Master
Development
Drainage
Plan /
Preliminary
Drainage
Report

Eagle Rising

Project No. 61145

PCD File No.: SP205

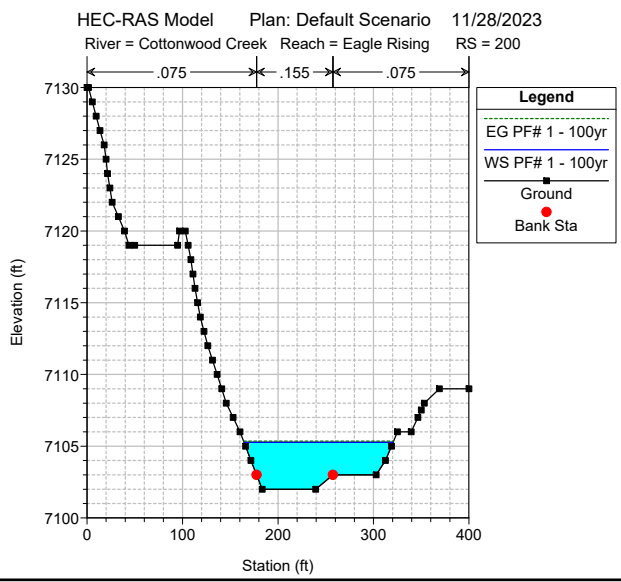
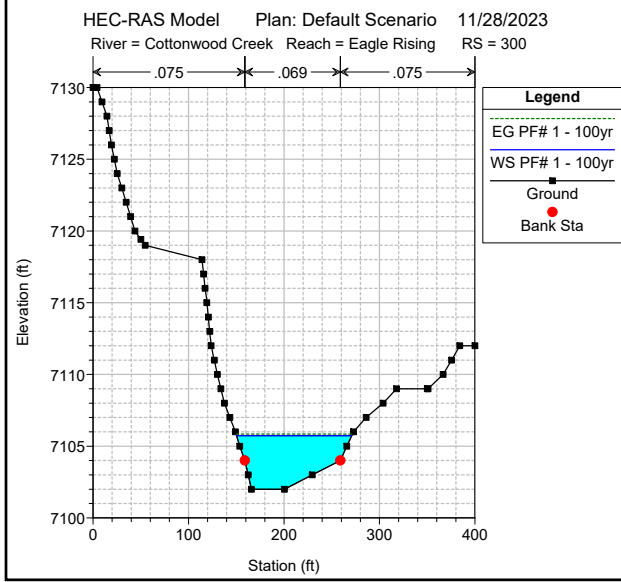
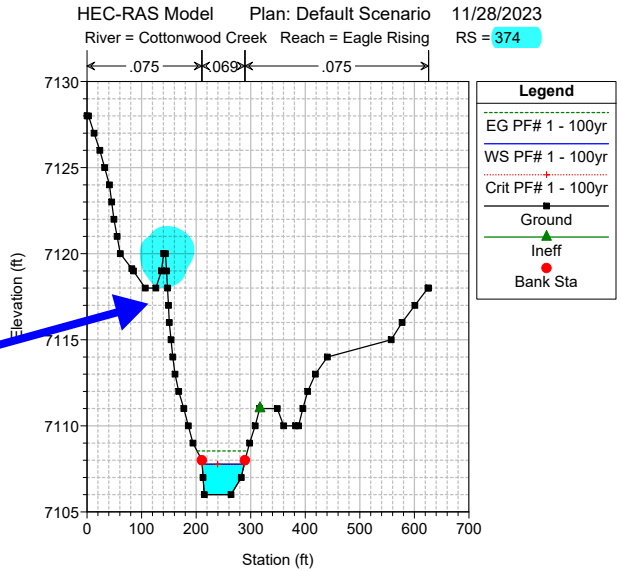
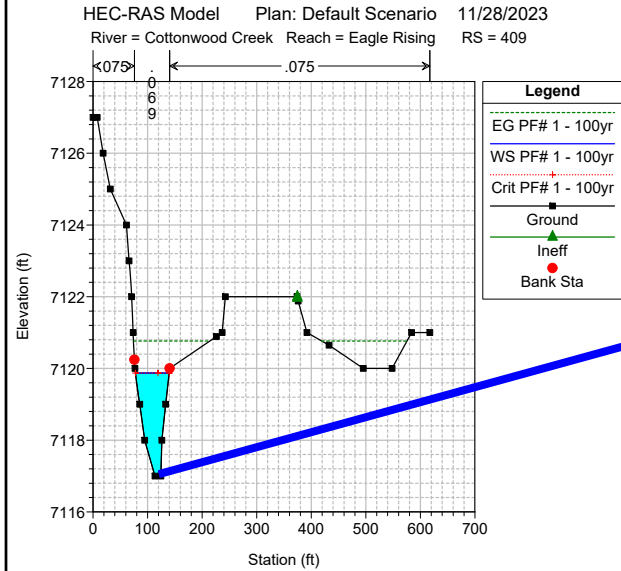
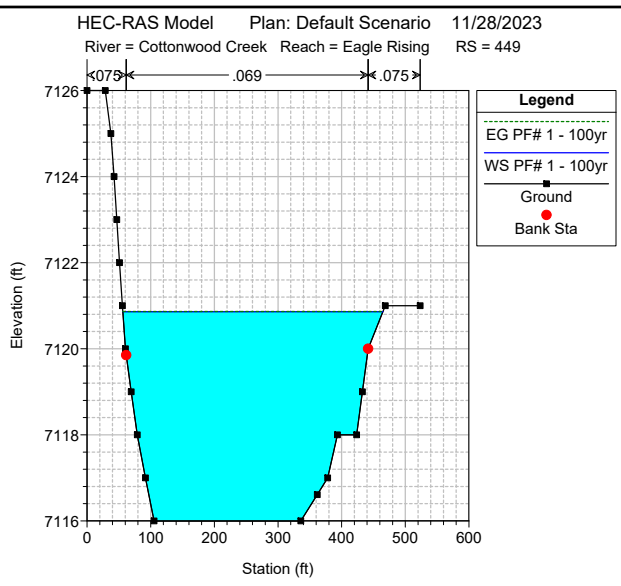
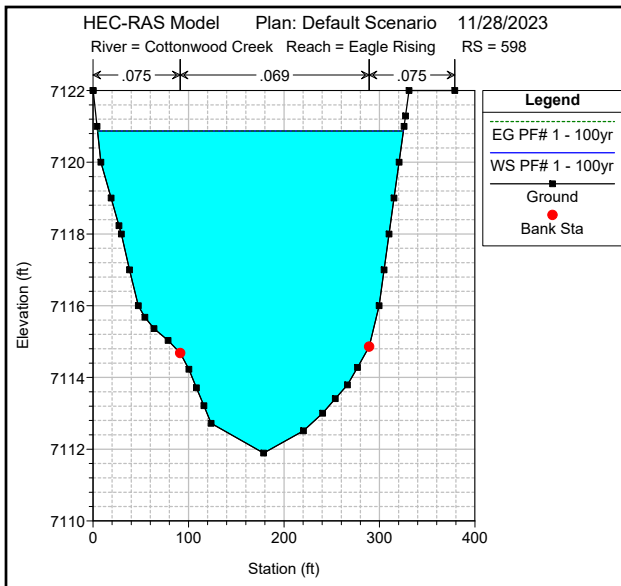
as-builts will be required to verify usefulness

as-builts will be required to verify usefulness

as-builts will be required to verify usefulness

as-builts will be required to verify usefulness

Looking at riprap on tributary flow upstream of DP6B, from Design Point 6A.

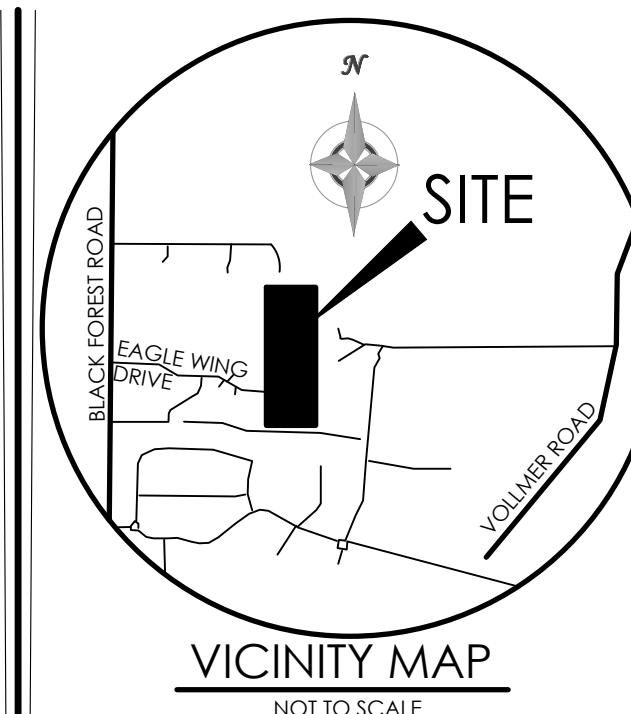
riprap not shown on plans?

PROPOSED
 DRAINAGE MAP
 HECRAS SECTIONS

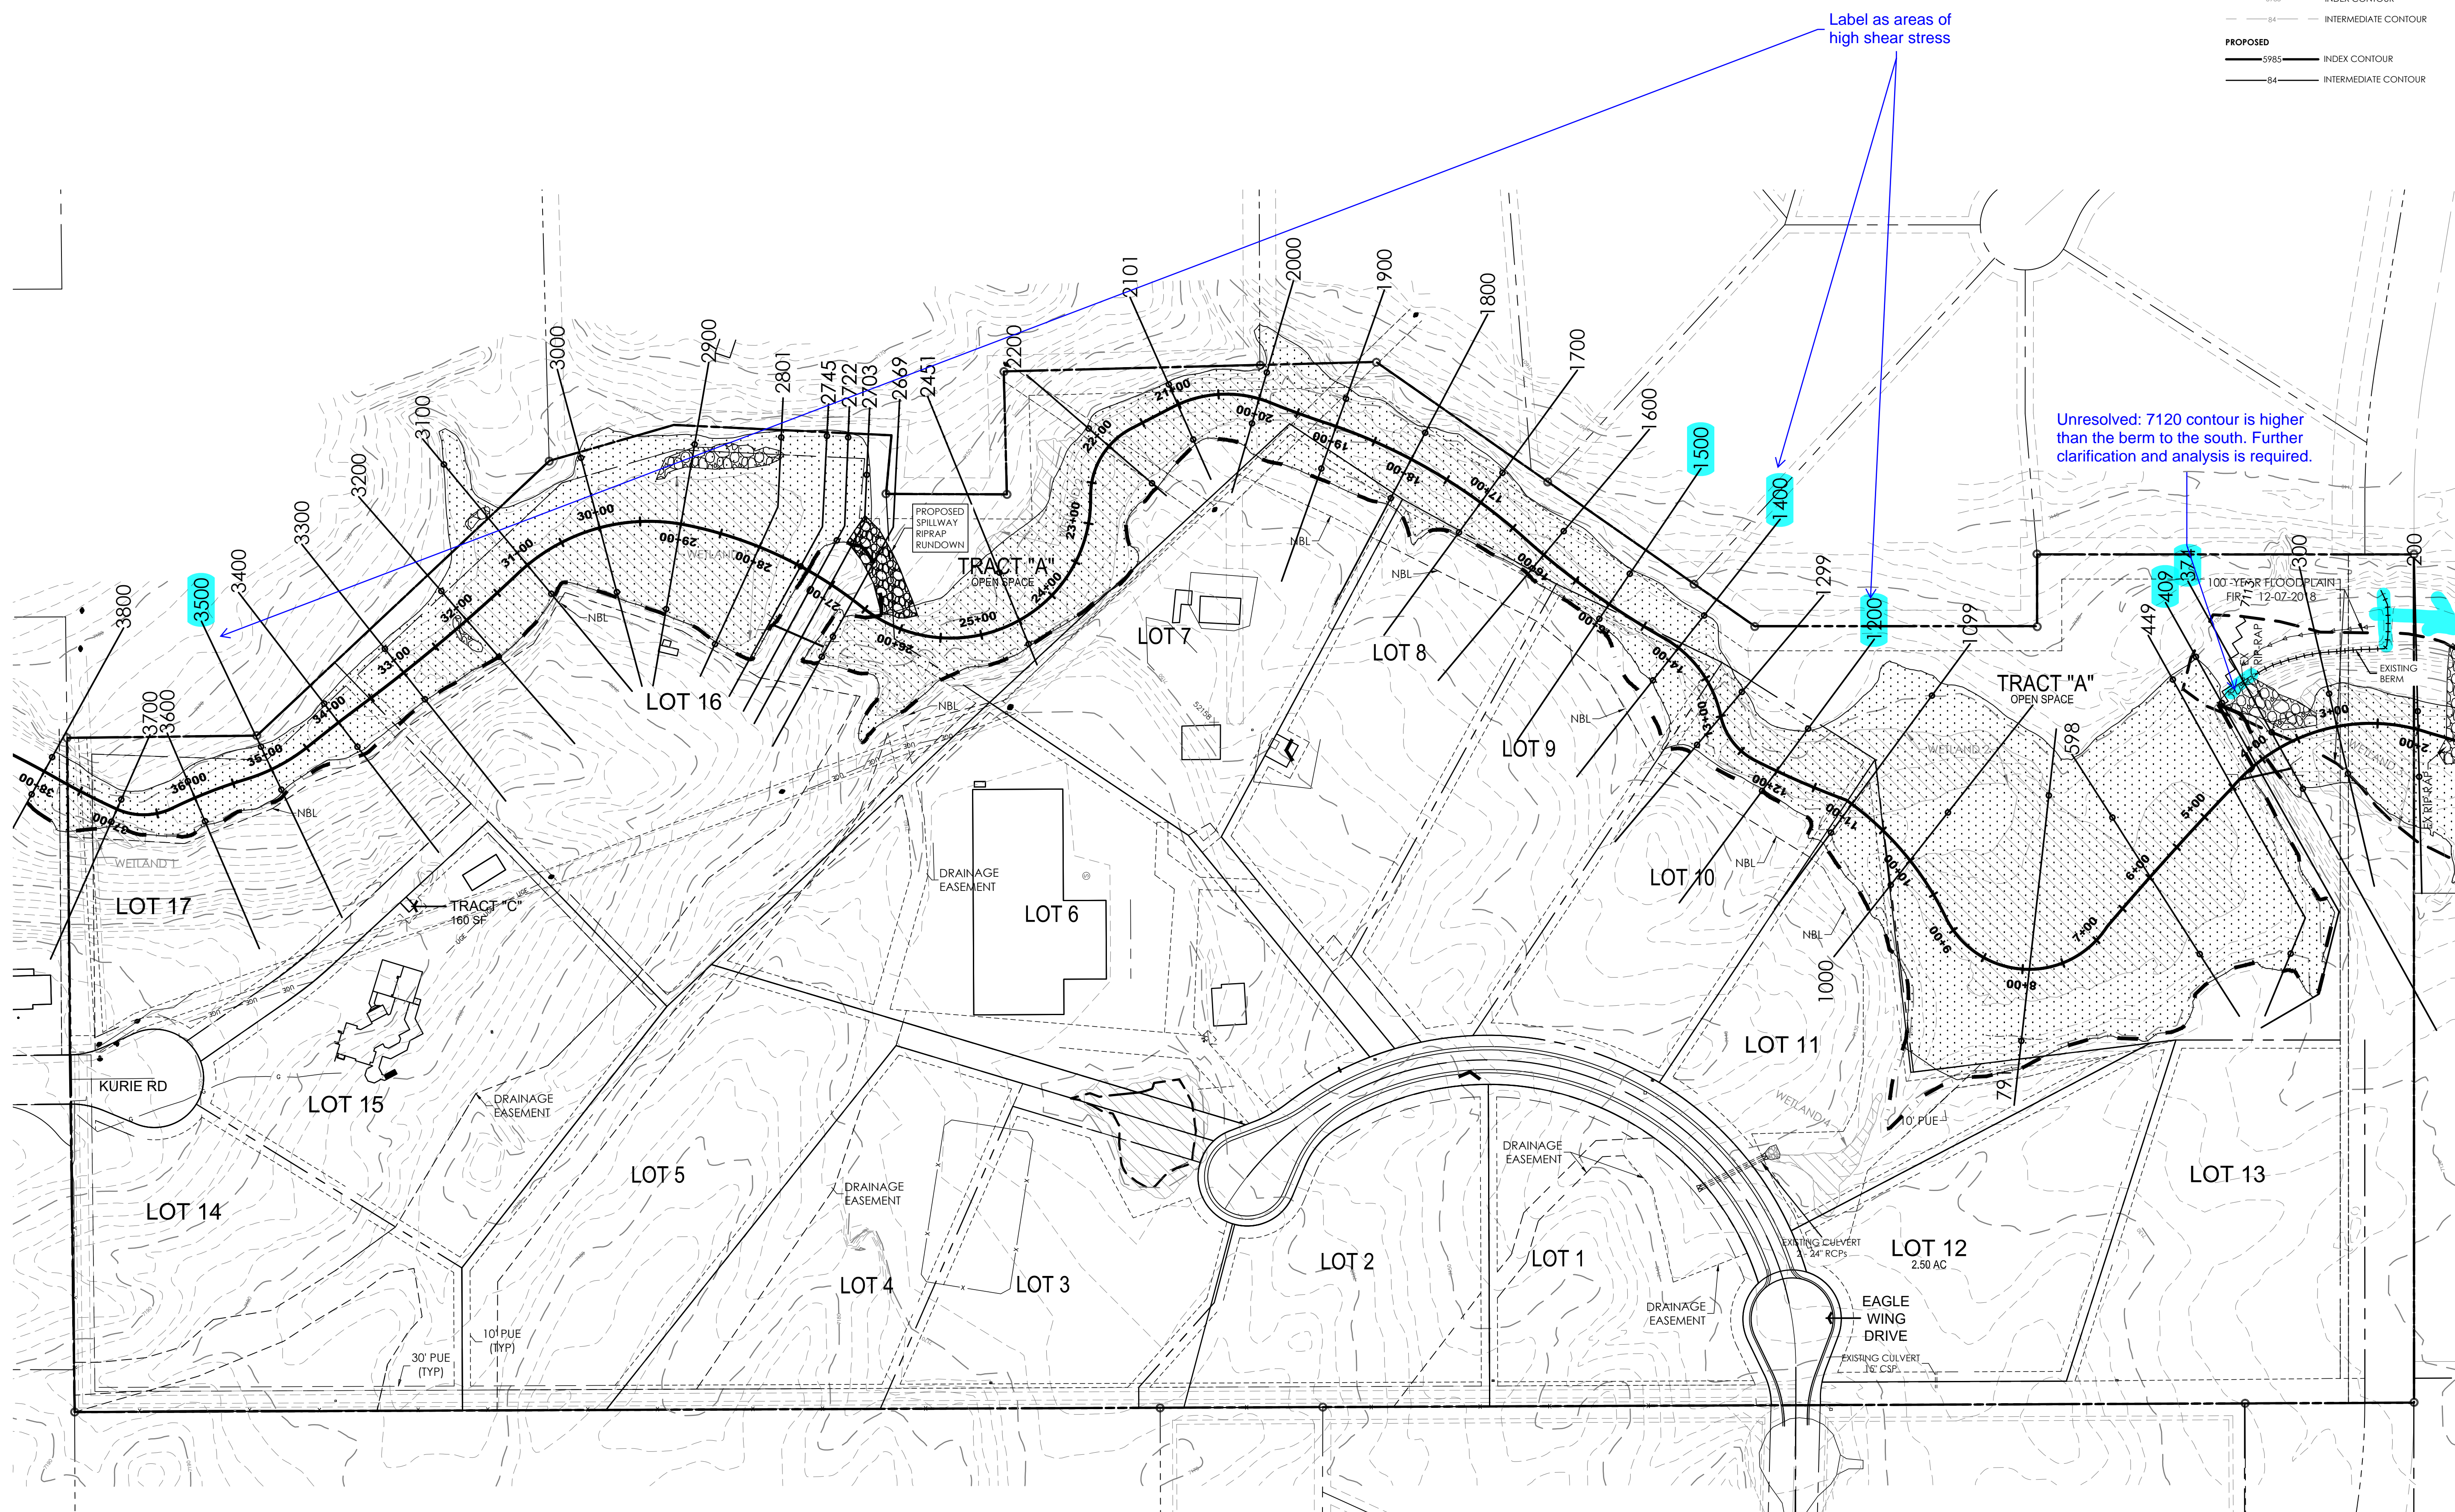
Label as areas of high shear stress

Unresolved: 7120 contour is higher than the berm to the south. Further clarification and analysis is required.

Area of concern is highlighted - direction of flow (unresolved)

(Unresolved) regrading appears to be needed to direct flow into the spillway

Areas of concern are highlighted
